Subject: Submission: DA2021/1200 FAO Mr Phil Lane

Re: Submission for DA2021/1200

Our comments relate to the proposed 'South bedroom wing' within DA2021/1200 which is: non-compliant with a number of northern beaches council planning regulations relating to boundary setbacks and building envelope; contravenes planning rules for its E4 zoning as set out in the NSW Government's Pittwater Local Environmental Plan 2014; is out of keeping with the building requirements for environmentally sensitive land as set by the Council; and is not in keeping with the Council's stated objectives for the future character of the Bilgola locality.

Figure 1: Impact on Field of view from Master Bedroom and Bathroom

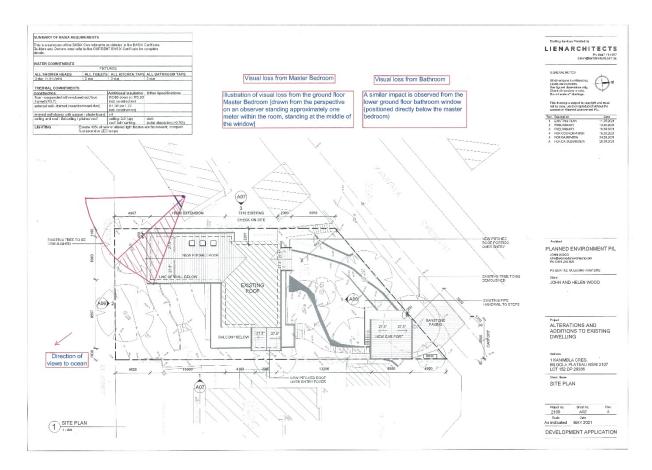
The proposed 'South bedroom wing seeks significant non-compliance with the western boundary, southern boundary setbacks and the building envelope. This results in an imposing building which crosses directly in front of our master bedroom window at the western boundary resulting in a ~40% loss in visual field and a significant obstruction of views to the East across Attunga Reserve. This can be seen in Figure 1 and Illustration A.

The proposed 'South bedroom wing' also results in a greater loss of views and light to the lower ground bathroom picture window which frames the bush outlook as can be seen in Illustration A.

We acknowledge that we enjoy expansive views from other areas of our house and are certainly not opposed to view sharing. Our objections relate more to having an imposing and dominant building at such an oppressive proximity in direct line of sight that is of such bulk and scale it is not possible to screen.

Figure 2: Impact on private garden space

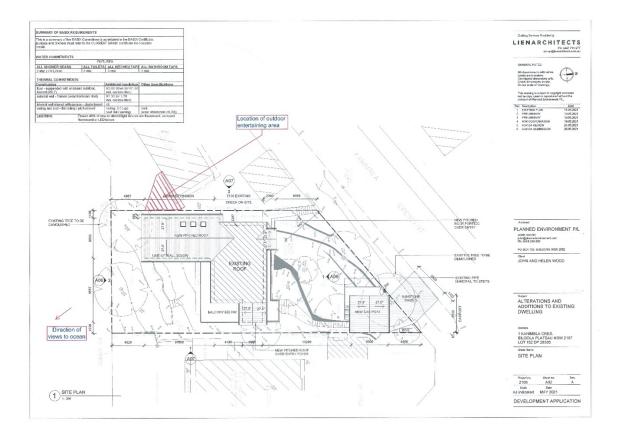
Consistent with the failure to illustrate the significant adverse impact to the views of 3 Kanimbla Cres as set out in point 2 above, DA2021/1200 also omits to illustrate or address the impact the proposed 'south bedroom wing' would have on our private terraced garden area that sits on the west boundary (illustrated in Figure 2 and photos below).

The bulk and scale of the proposed 'South bedroom wing' will be visually and spatially imposing, destroying the character of this private space which joins the nature reserve. [see photos below]

Noting – the application also proposes to remove remaining protected tree seen in the right hand side of the picture In particular, by seeking to significantly non-comply with building envelope regulations by approximately 4.1 metres (117%) together with non-compliance on the western and southern boundaries results in a ~9.2 metre high building to the left of our garden almost in touching distance at only 1.1m from where we are sitting. The visual dominance of the proposed non-compliant building to 3 Kanimbla Cr is exacerbated by the angle of the western boundary between plot No. 1 and plot 3 Kanimbla Cres.

From the lower level terrace of our garden this will be up to 11metres in height at foot level. DA DA2021/1200 suggests that these issues can be resolved by planting native vegetation. However, it is not possible to screen a building that is up to 11 metres height just 1 metre from the boundary, with any vegetation either immediately or in the distant future. It is also worth noting that due to strong southerly winds and shade it is incredibly difficult to grow even low level plants and vegetation in this area. It is unknown what impact the shade from the proposed development would have on existing native ferns and palms on our southern boundary.

As a result, the proposed building will dominate its environment, which is contrary to Pittwater 21 DCP objectives, which states that: "In residential areas, buildings are to give the appearance of being **secondary** to landscaping and vegetation".
